UNITED STATES
DEPARTMENT OF THE INTERIOR
BUREAU OF LAND MANAGEMENTFORM APPROVED
OMB NO. 1004-0135
Expires: July 31, 2010**SUNDRY NOTICES AND REPORTS ON WELLS**
*Do not use this form for proposals to drill or to re-enter an abandoned well. Use form 3160-3 (APD) for such proposals.*5. Lease Serial No.
NMSF078487A

Florance 108-PC
API: 30-045-23420-00
San Juan County, New Mexico

Re: Permanent Abandonment
Well: Florance #108

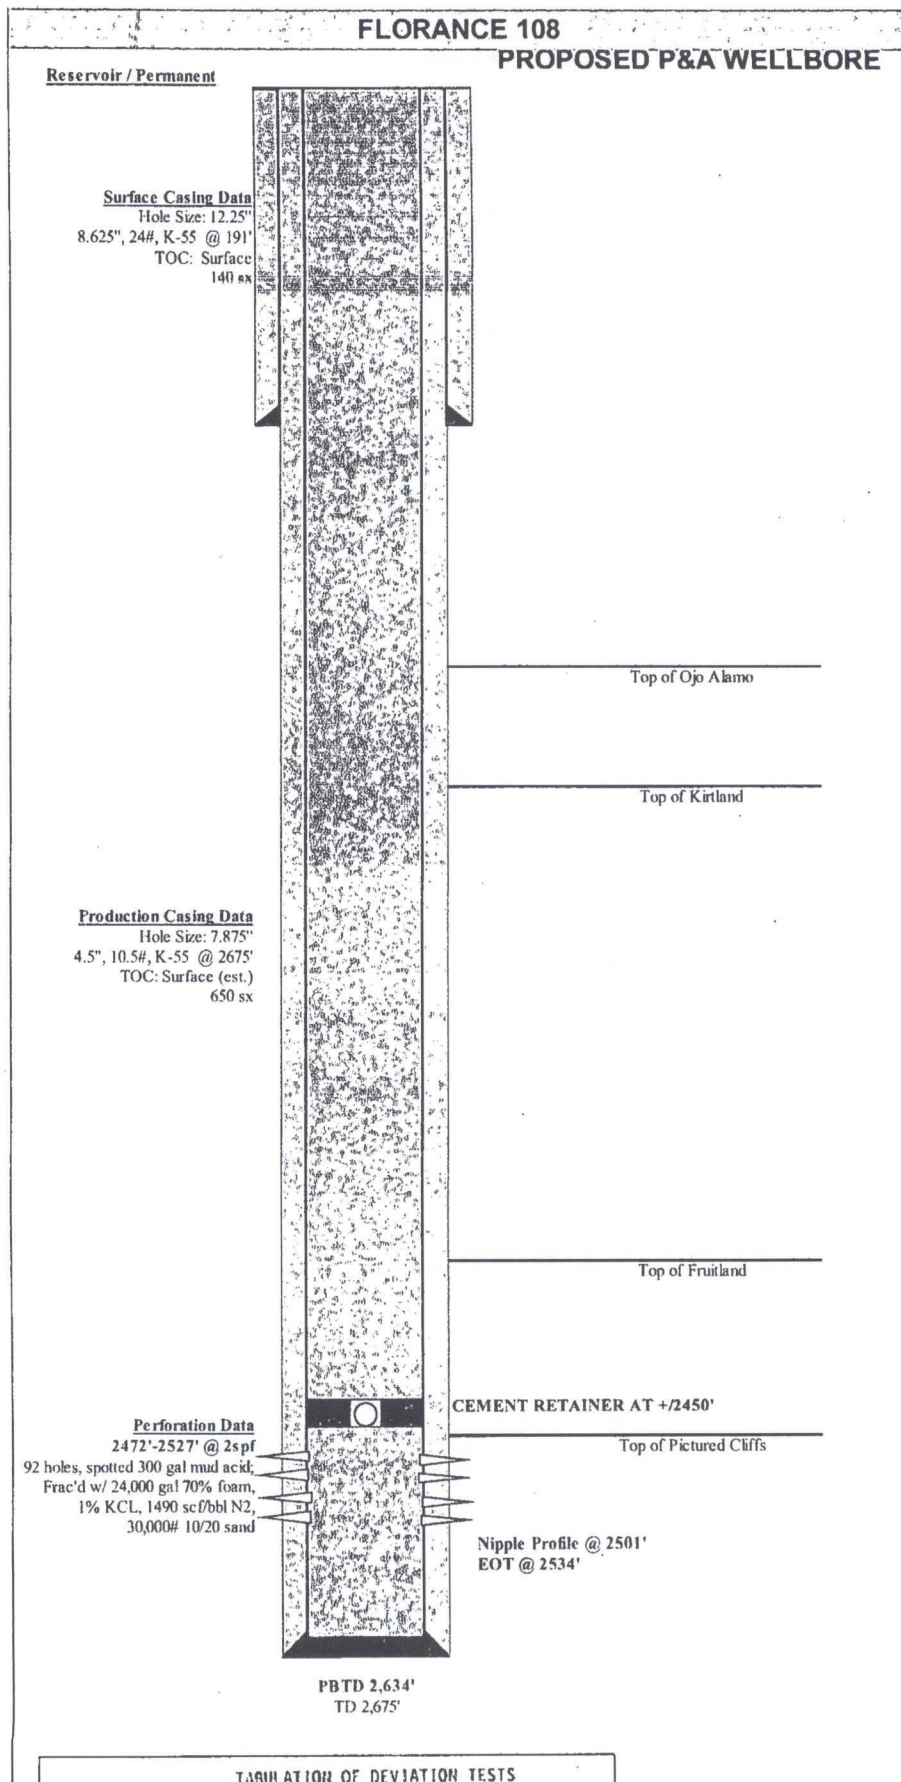
Operator will run a CBL from 2470 ft. to surface. Outside plugs might be required, per CBL result. Submit an electronic copy of the log for verification to the following BLM address: tsalyers@blm.gov

You are also required to place cement excesses per 4.2 and 4.4 of the attached General Requirements.
